TECHNICAL BULLETIN

Product : Machine Room-less System 21 Passenger Lifts

Subject : Modification to Remote Hand Pump Housing.

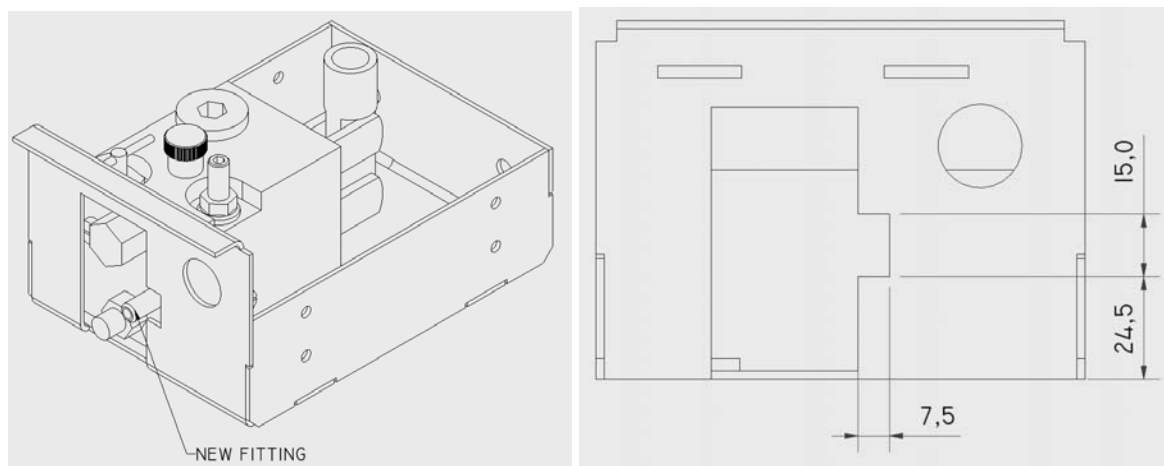
Changes have been made to the design of the remote hand pump unit that will make it necessary to modify the hand pump housing located in the lowest landing entrance. Material must be cut away to accommodate a new fitting that has been added to the bottom of the hand pump block. See below for cut-out details.
